5-6-2021

This letter is a follow up letter to the one we previously sent on April 2, 2001 regarding the revised 5-Lot subdivision on Canyon Creek S.

ATTACHMENT: Revised Lot Plans

Option A:

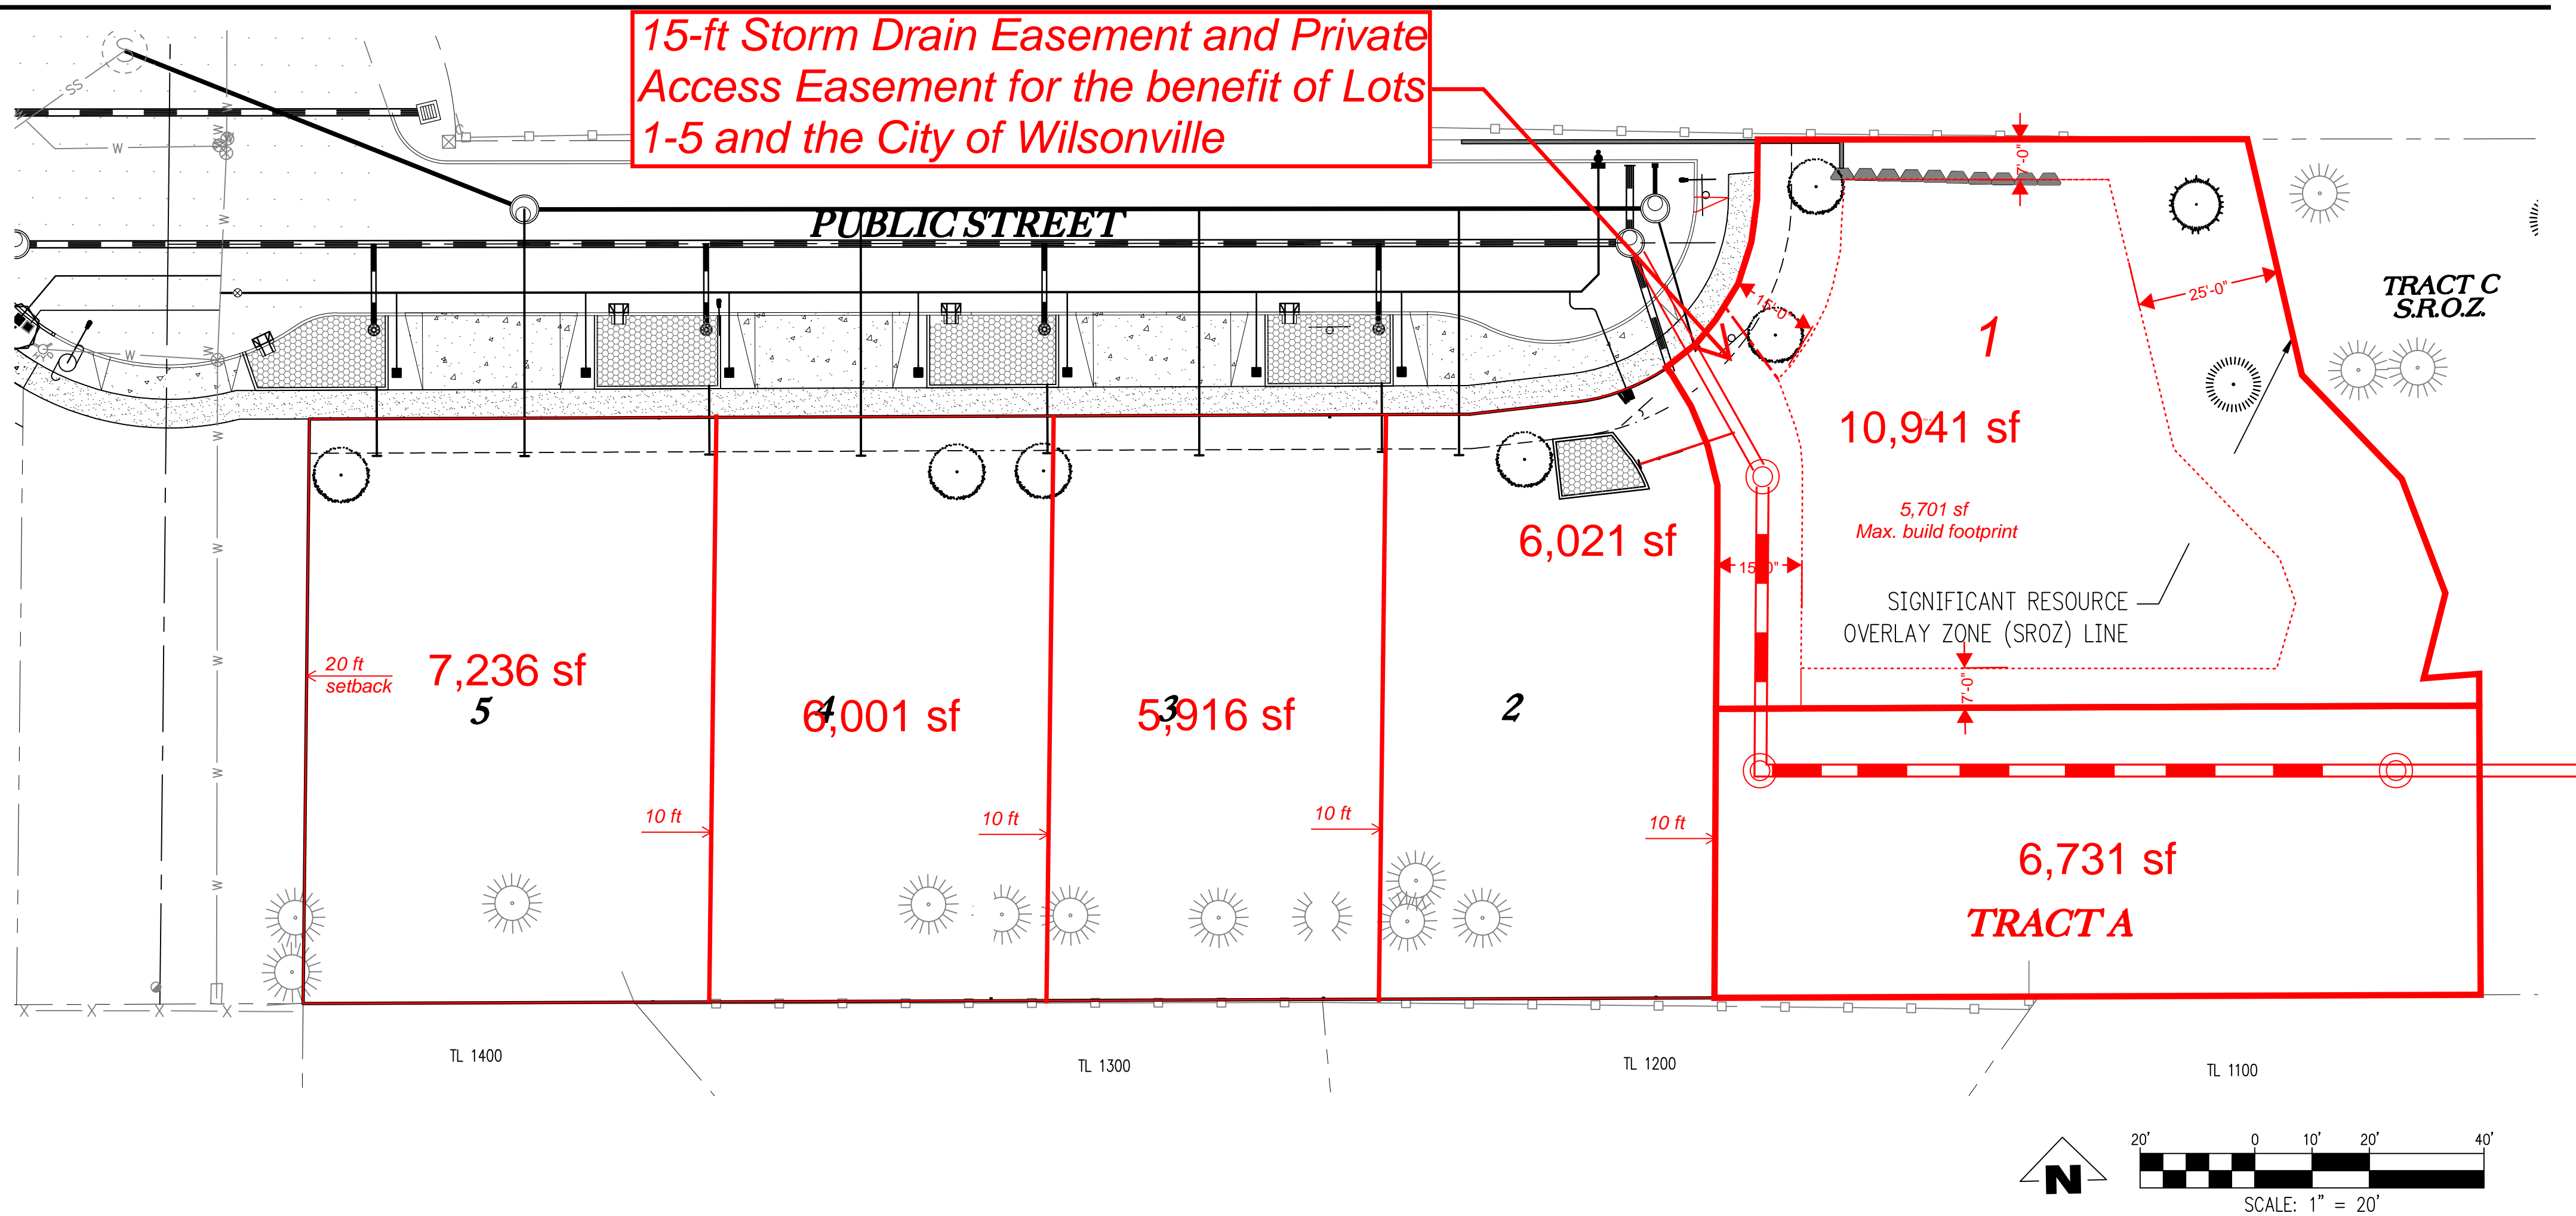
- Lots 2-5 unchanged
- Lot 1 is 12,000 sf, 6,400 sf max. building footprint
- Lot 1 has 15' easement through side
- Serves as utility and public access
- Tract A includes storm pipes
- No private drive, just unpaved path
- 10 additional trees saved

Option B:

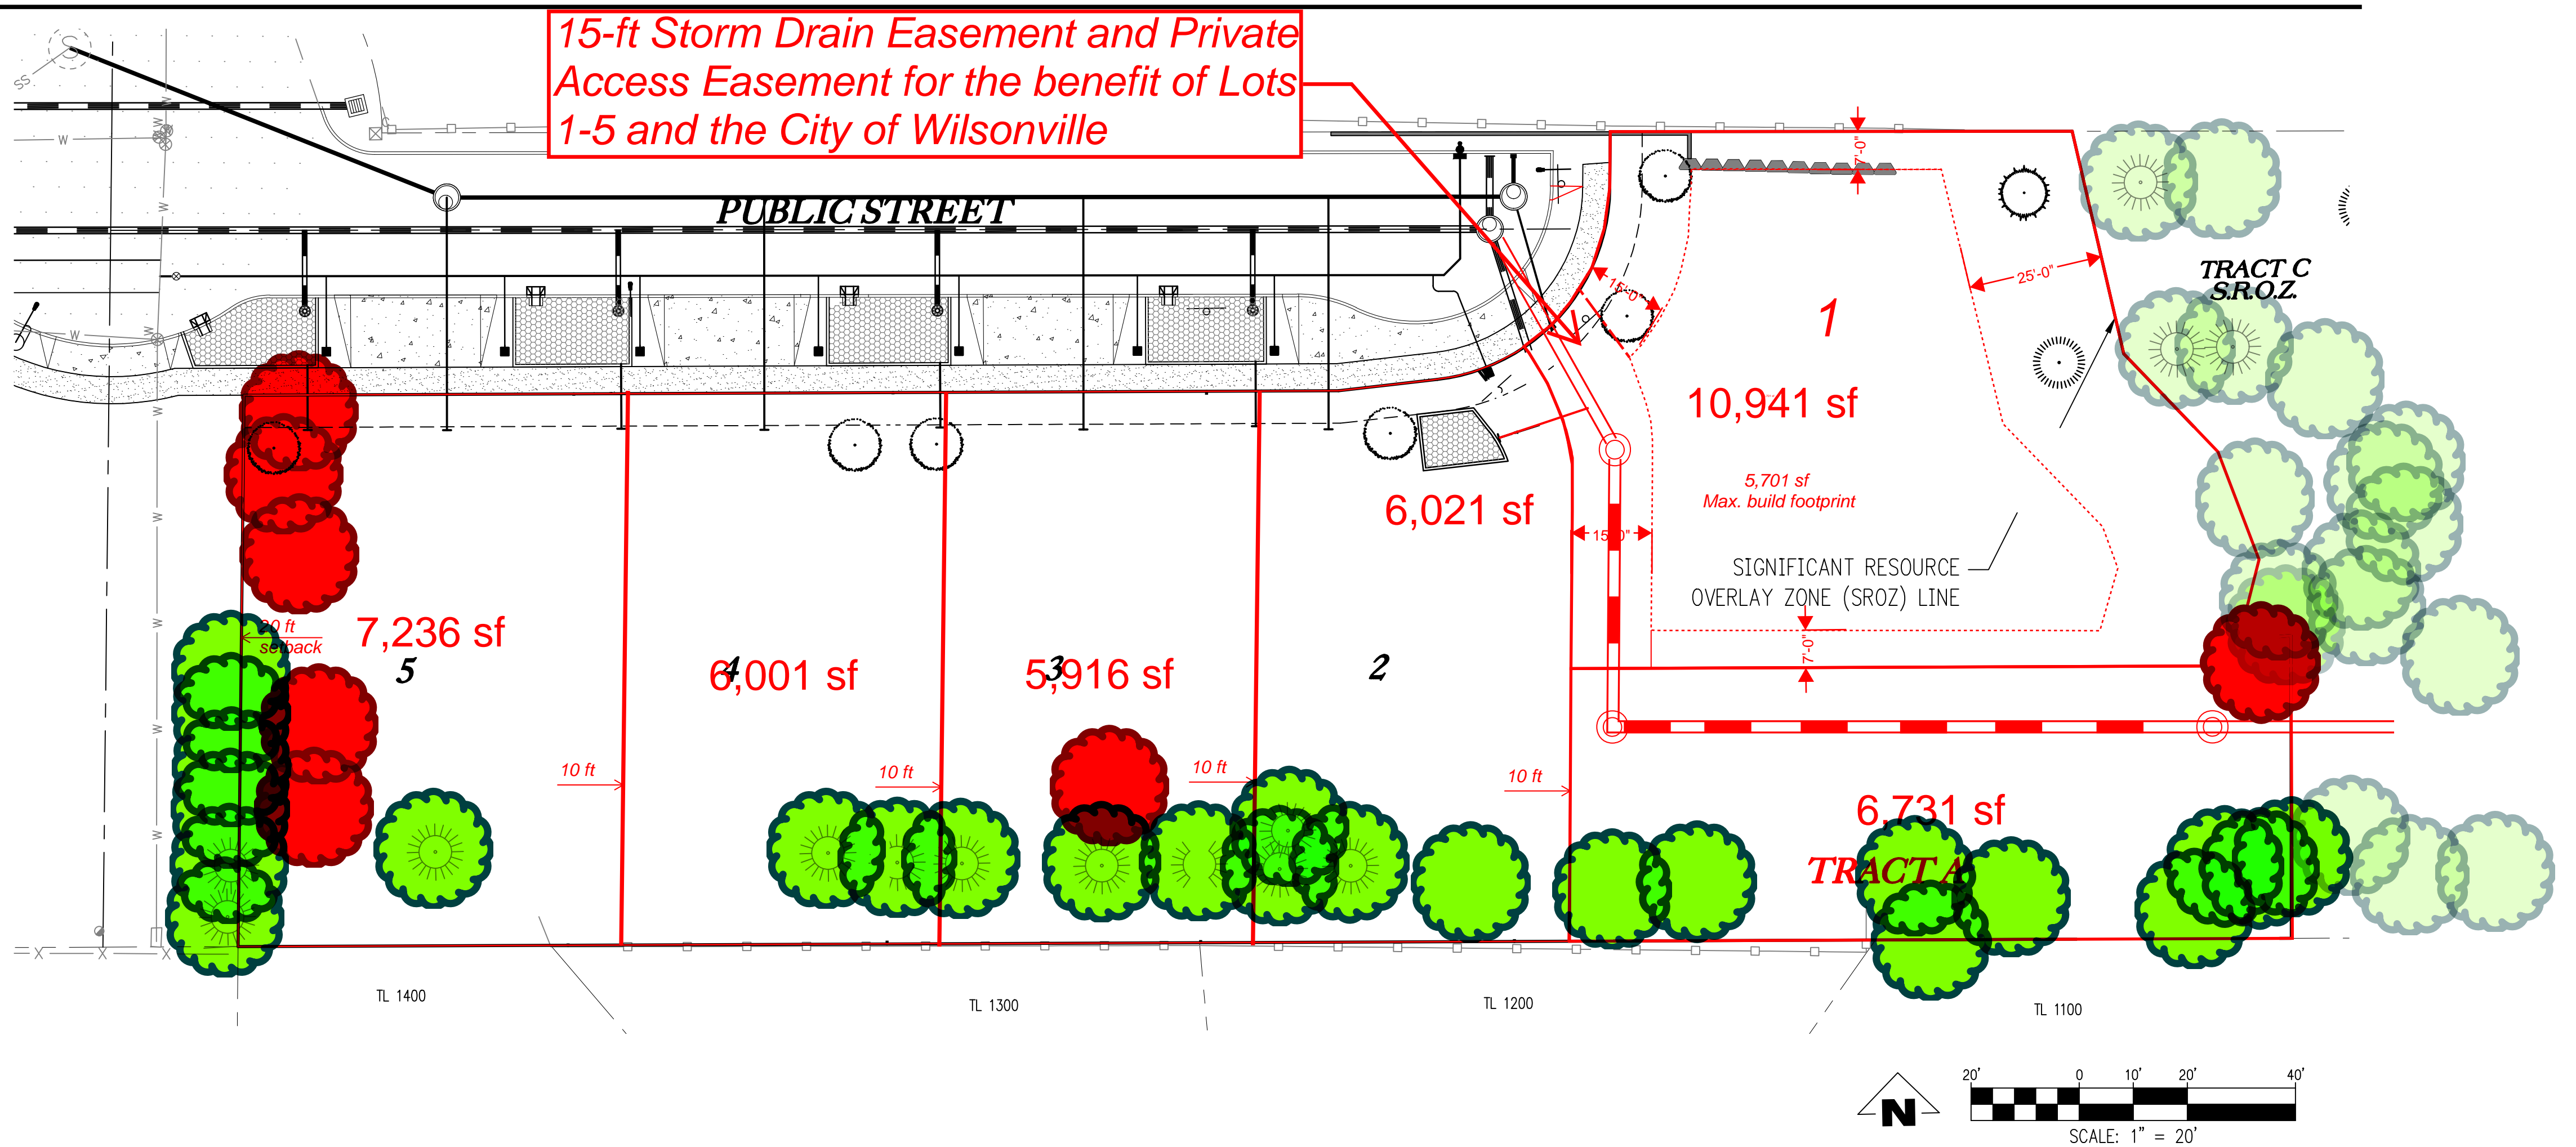
- Lots 2-5 shifted 10 feet east
- Provides 20' setback on west side of lot 5
- Lot 5 is 7,236 sf with 20 ft setback on east side
- Lot 1 is 10,900 sf, 5,700 sf max. building footprint
- Lot 1 has 15' easement through it
- Serves as utility and public access
- Tract A includes storm pipes
- No private drive, just unpaved path
- 14 trees saved
